SERVICE BULLETIN

OIL - PROVIDE A NEW OIL TANK CAP PLACARDED WITH THE CORRECT TANK CAPACITY - CATEGORY
CODE 3 - MOD.ENG-79-0003

V2500-ENG-79-0003

Remove and install the cap of the oil tank
Fig.1

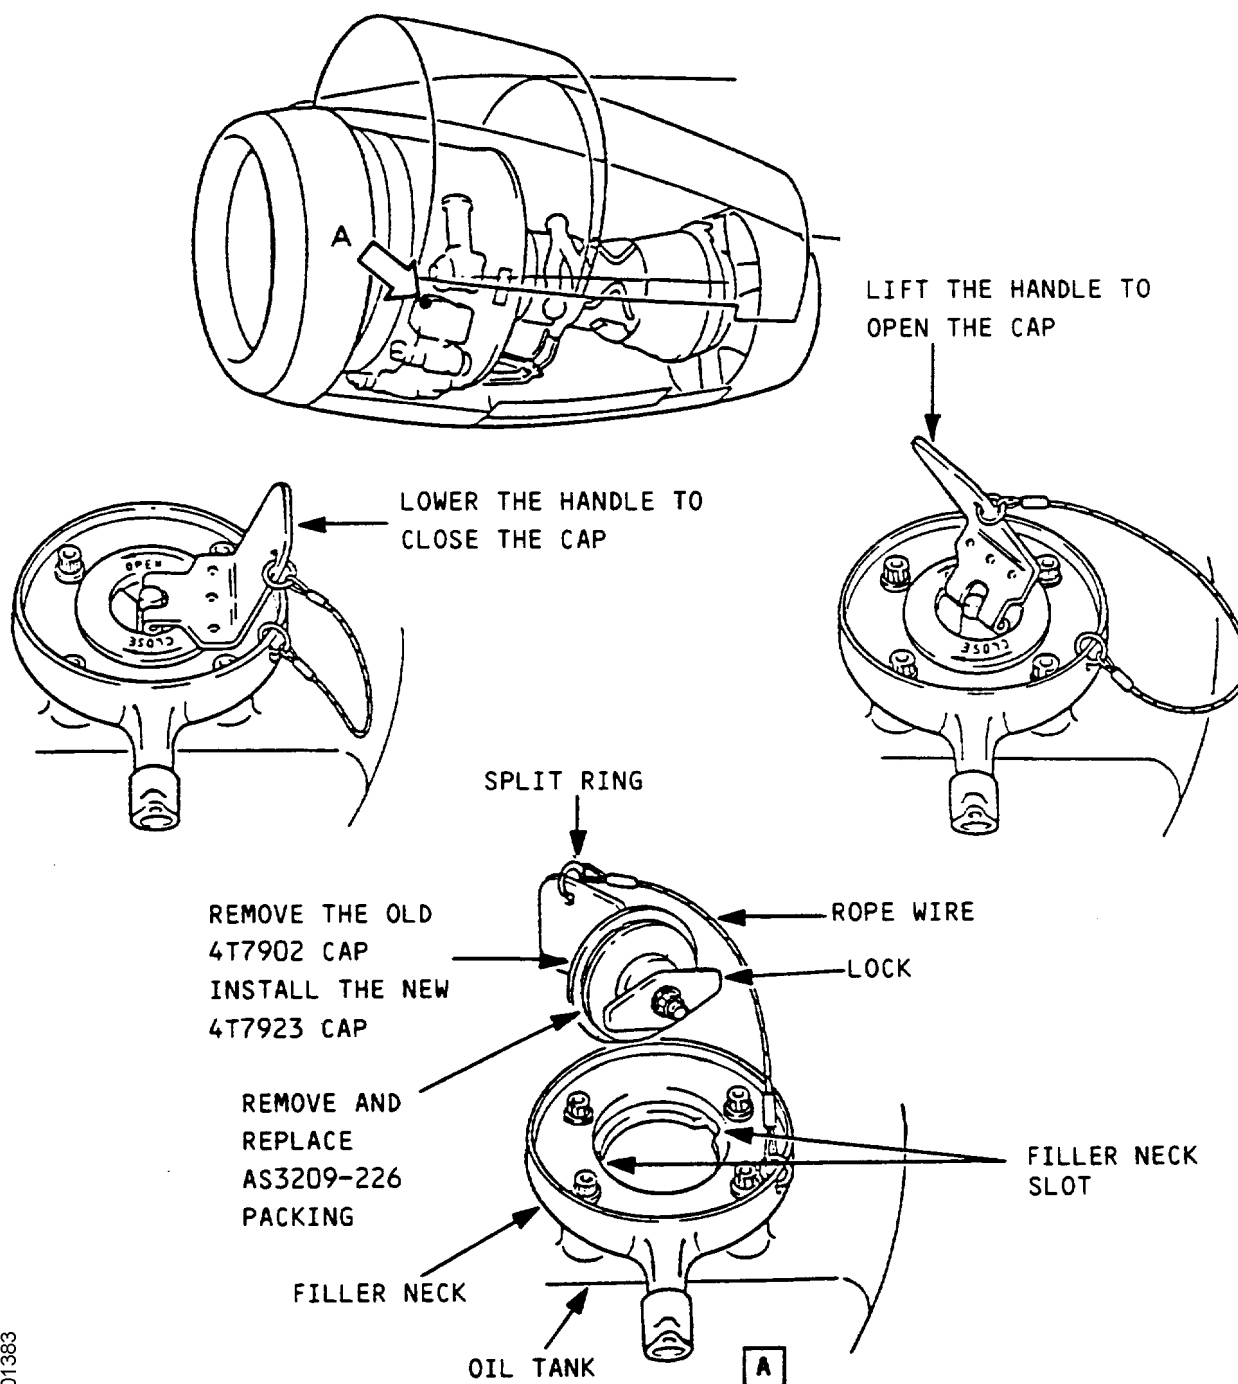
Oil filler cap and cover marking with capacity in Imperial Gallons. To eliminate this condition the capacity of the oil tank is to be indicated U.S. QTS.

Facility in reading the new marking. In order to comply with this requirement for a satisfactory reading on the cap, the marking has been rotated.

The new oil tank cap placarded with the correct oil tank capacity is put in place of the old cap.

- (2) Drain the oil tank, refer to Aircraft Maintenance Manual, 12-13-79.
- (3) Remove the cap. Ref Figure 1.
 - (a) Lift the handle from close to open position.
 - (b) Turn counterclockwise the cap until the lock is aligned with the filler neck slots.
 - (c) Remove the cap.
- (4) Open the split ring and remove the old PN 4T7902 cap from the rope wire which connect the cap to the filler neck of the oil tank.
- (5) Remove the cover from the oil tank. Ref Figure 2.
 - (a) Remove the four PN 4W0163 bolts which attach the cover to the oil tank.
 - (b) Remove the old PN 4B7032 cover from the oil tank and discard the PN AS3209-148 packing.
 - (c) Loosen and remove the two PN MS9902-06 and MS9902-08 plugs from the cover.
 - (d) Remove and discard the two PN AS3208-60 and AS3208-08 packings from the plugs.

- (h) Install the plug on the cover and torque to 51 to 53 lbfin (6 to 8).
 - (i) Safety the two plugs with V02-141 lockwire.
 - (2) Connect the new PN 4T923 cap to the split ring of the rope wire which connect the cap to the filler neck of the oil tank. Ref Figure 1.

- (3) Install, if necessary, new PN AS3209-226 packing on the cap.
 - (4) Fill the oil tank, refer to Aircraft Maintenance Manual, 12-13-79.
 - (5) Close the oil tank. Ref Figure 1.

- (a) Align the lock of the cap with the two filler neck slots and install on the oil tank.
 - (b) Turn the cap clockwise until it stops.
 - (c) Lower the handle of the cap from open to close position.
